Air Gap Adaptor Fitting

SPECIFICATION SUBMITTAL SHEET

Shop Drawing Submittal Review

Project Name: Webster University-**ISB**

BFP-4 BACKFLOW PREVENTER PER ADDENDUM #2-1

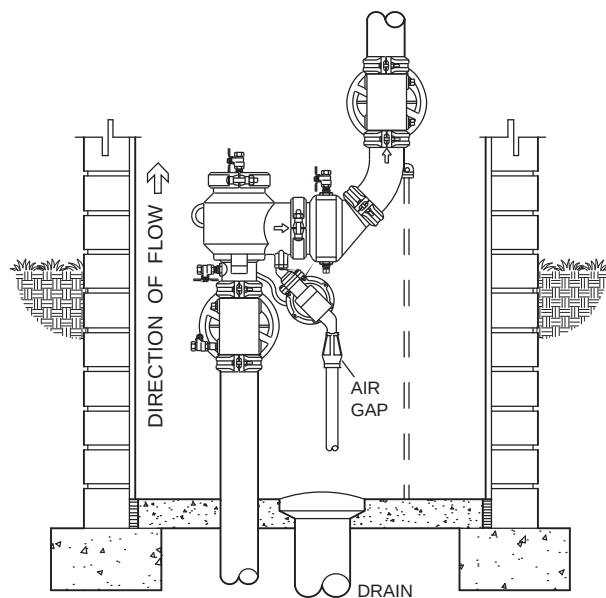
1. BFP-4 - Provide caps and tethers for each test cock.
